**FROM:** GRAEF  
Dominic Marlow, AICP, Village Planner, GRAEF

**SUBJECT:** Review of the following:

- 1) A Site Plan Review on tax parcel #37-4-121-172-0201

Re: Plan Commission Submittal Comments–January 28, 2025  
Preliminary Plan Review Comments for 8555 194th Avenue  
Tax Key ID 37-4-121-172-0201  
Village of Bristol, Wisconsin (Village)

**Figure 2: Site Plan (Source: Applicant)**

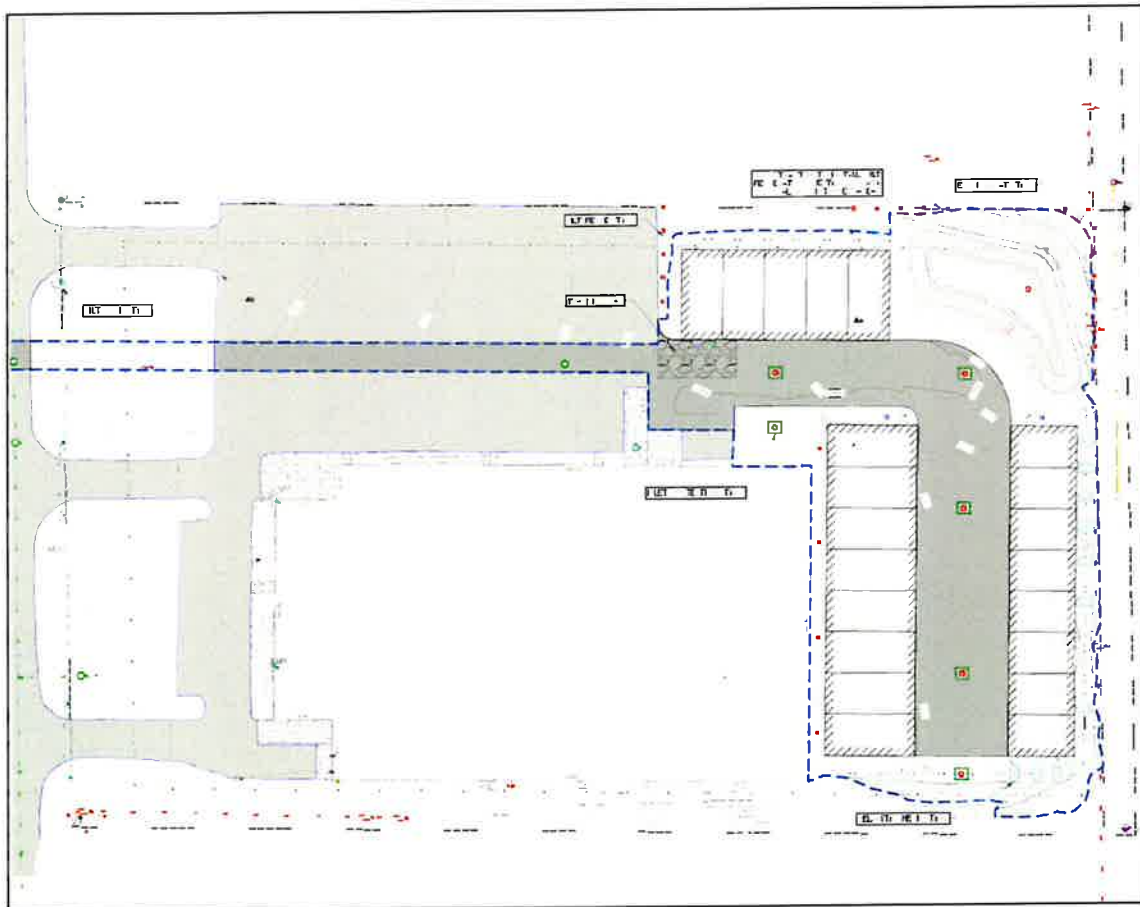
- ii. No street bufferyards are proposed. A Type 2 Street Bufferyard is required for site plans in the M-2 District along a non-highway street. The existing vegetation may count towards the required bufferyard.

- iii. The Applicant shall submit a revised landscape plan showing a street bufferyard with Intensity Factor 2 or greater along 194<sup>th</sup> Ave.

- 1) The Applicant shall submit a revised landscape plan showing a street bufferyard with Intensity Factor 2 or greater along 194th Ave;
  - 2) The Applicant shall apply and receive approval for any proposed signs before installing signs on the Subject Property;
